# 2025 L Street / 2101 Capitol Avenue Mixed-Use Project

Final Environmental Impact Report

Project No. P14-045 - SCH No. 2014112053

**Exhibit 2-2. Construction Schedule Estimate**

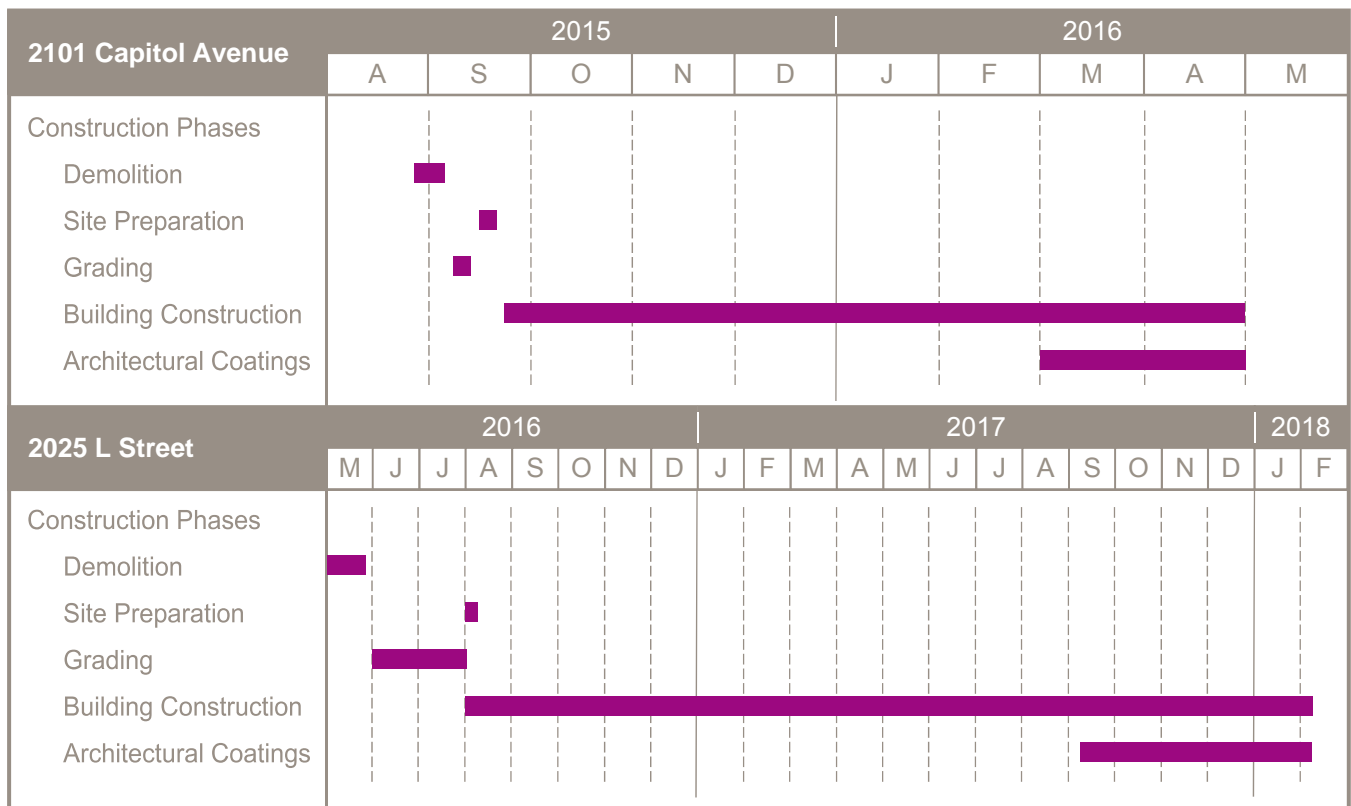
5. Section 4.7, Mitigation Measure 4.7-5: Please indicate when the project applicant will develop the Construction Traffic Management Plan. The draft EIR states that the plan is "... subject to review by all affected agencies ...." Will the draft traffic management plan also be made available to the public for review? If not, how can a City resident access or obtain a copy of the final plan? As a nearby resident, I am particularly interested in ensuring vehicle and pedestrian safety during construction activities. I 16-6

As discussed in the Draft EIR (see page 2-24, in particular), the project is currently anticipated to start with construction on the 2101 Capitol Avenue portion of the project site in late summer 2015, extending into spring 2016. Construction on the 2025 L Street site would occur between spring 2016 and the end of 2017. See also the discussion on page 4.2-15 of the Draft EIR under the heading, “Construction.”

As noted, construction would consist of building demolition, grading, site preparation, building construction, and application of architectural coatings. The proposed project would be built out over multiple years. For the purposes of the analysis reported in the Draft EIR, it is assumed build-out of both phases would occur over an approximate 2.5-year period, spanning portions of three calendar years (i.e., 2015, 2016, and 2017). The City has also provided a schedule graphic, below, to help illustrate the current assumed timing of construction (Exhibit 2-2). While the timing of construction represents the best available current knowledge, this is subject to change based on factors outside the control of the City and the project applicant.

Exhibit 2-8.

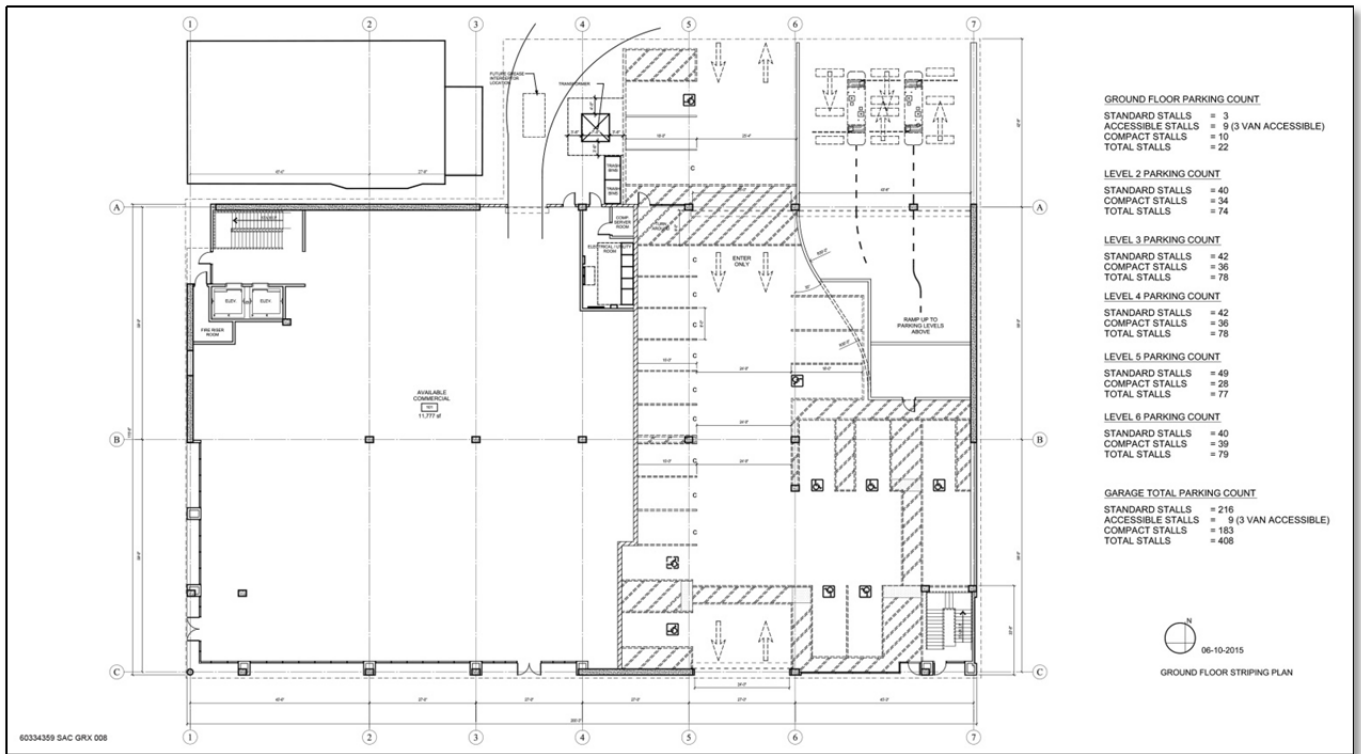
Page 2-17, Exhibit 2-8 has been revised for the 2101 Capitol Avenue portion of the project site.

This illustrates the change in the proposed project to move the proposed parking structure at the 2101 Capitol Avenue portion of the project site further from Liestal Alley and further from the St. Anton apartment building.

**Exhibit 2-9. 2101 Capitol Avenue Exterior Elevations (from North and from South)**

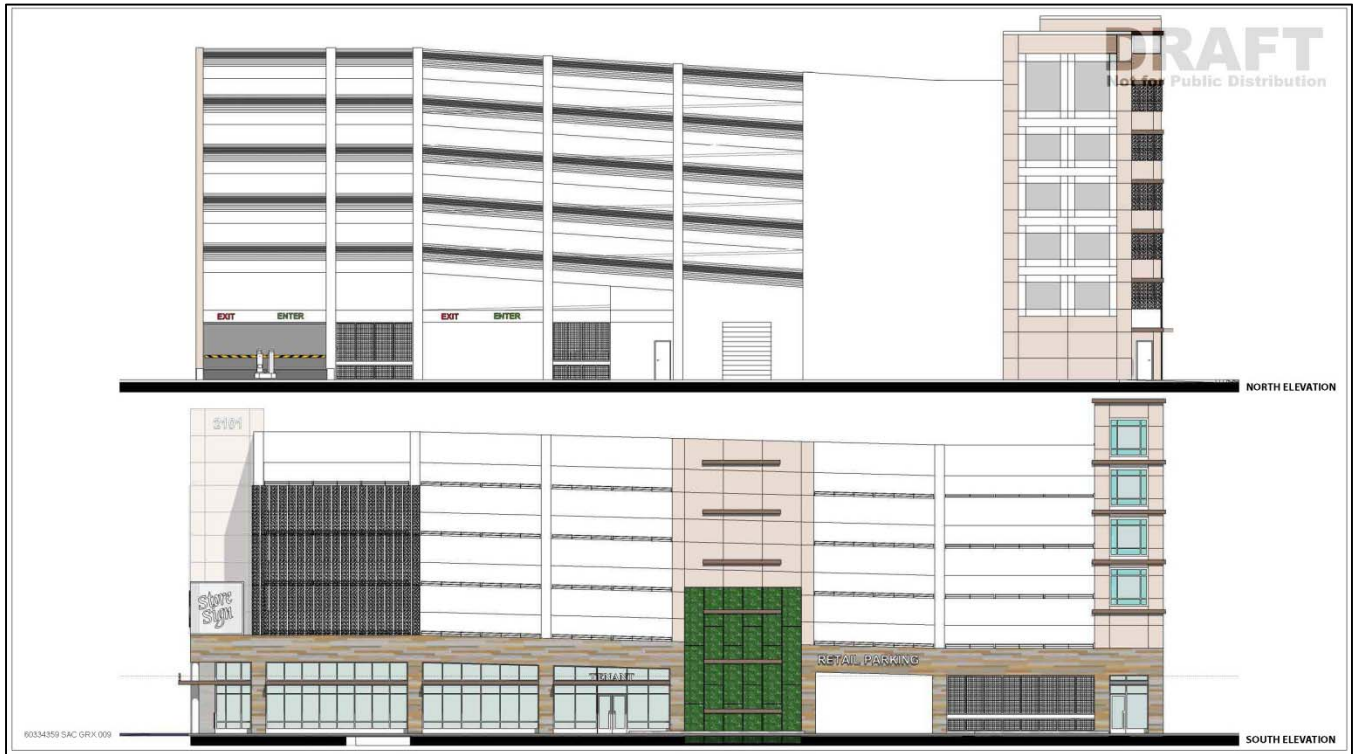
Exhibit 2-9 has been revised for the 2101 Capitol Avenue portion of the project site.
